D206-667-247TRN
Job Sheet 165929

Part Name: Crosstube Assembly, Mid Aft

DRAWING NO. D206-667-247	TITLE CROSSTUBE ASS'Y (206L MID AFT)	REV. A	DART AEROSPACE LTD ENGINEERING ORDER		D.E.O. NO. D206-667-247-A-1	SHEET NO. SHEET 1 OF 1	SCALE NTS
DRAWN <i>92</i>	CHECKED <i>ASS</i>	MFG. APPR. <i>KD</i>	APPROVED <i>JMP</i>		DE APPR. <i>th</i>		
DATE 11.07.15	DATE 11.07.20	DATE 11.07.21	DATE 11/07/21		DATE 11.07.21

PURPOSE:

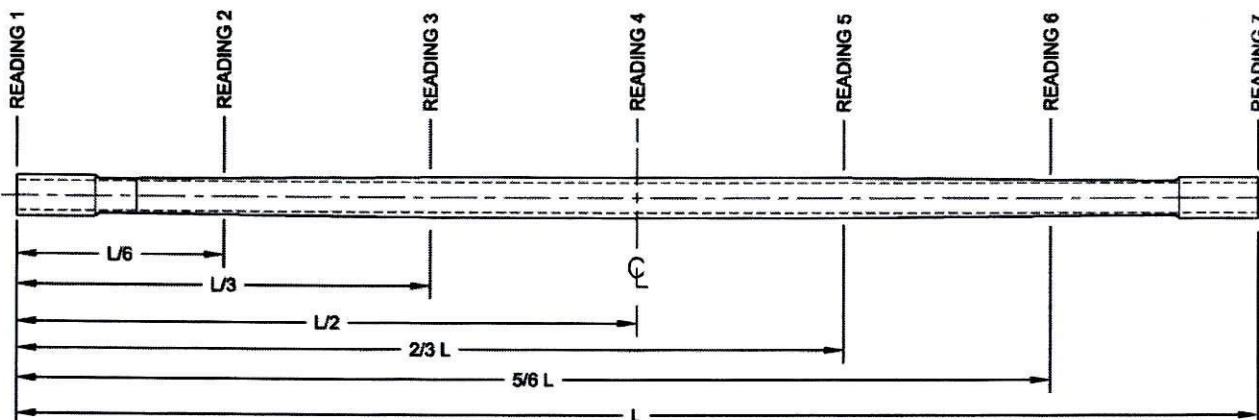
REPLACE MAGNOBOND WITH PROSEAL.

NOTE 12 & 15, SHEET 1 IS AMENDED AS FOLLOWS:

Item	Qty -247	Part Number	Description
9	A/R	PROSEAL 890 B-2	SEALANT, AMS-S-8802 CLASS B-2

- 12) TO INSTALL D2892-1 SUPPORT: ABRASE MATING SURFACE OF SUPPORT AND CROSSTUBE WITH 180-GRIT SANDPAPER AND REMOVE RESIDUE WITH MEK (OR EQUIVALENT). APPLY A 0.04" TO 0.07" THICK LAYER OF PROSEAL 890 CLASS B-2 (OR AMS-S-8802 CLASS B-2) SEALANT TO MATING SURFACE OF SUPPORT.
- 15) TORQUE CLAMPS 80 TO 100 IN-LB. ENSURE AT LEAST 1.5 THREADS SHOWING IN SAFETY AND THAT NUT HAS NOT BOTTOMED-OUT AFTER TORQUING. **PRIOR TO PACKAGING, RE-CHECK TORQUE ON CLAMPS AFTER PROSEAL 890 SEALANT HAS CURED FOR 72 HOURS.**
